PTCarPhone 3

Modifying the cable set, to get older PTCarPhone 3 systems ready for the headset solution

Figure: VDA connector of the cable set

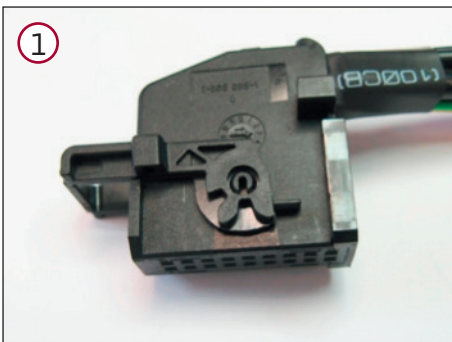
Under unfavorable circumstances, when using the headset solution with PTCarPhone 3 systems (PTCarPhone 3c systems are not affected), acoustic disturbances caused by the vehicle's electrical system might be perceivable as humming noises in the headset. A simple technical modification at the VDA connector of the

PTCarPhone cable set is necessary. This involves removing the thin black wire (GND of the second interface) from PIN 1 (vehicle ground) and adding it to PIN 7 (brown wire / speaker GND) of the VDA connector.
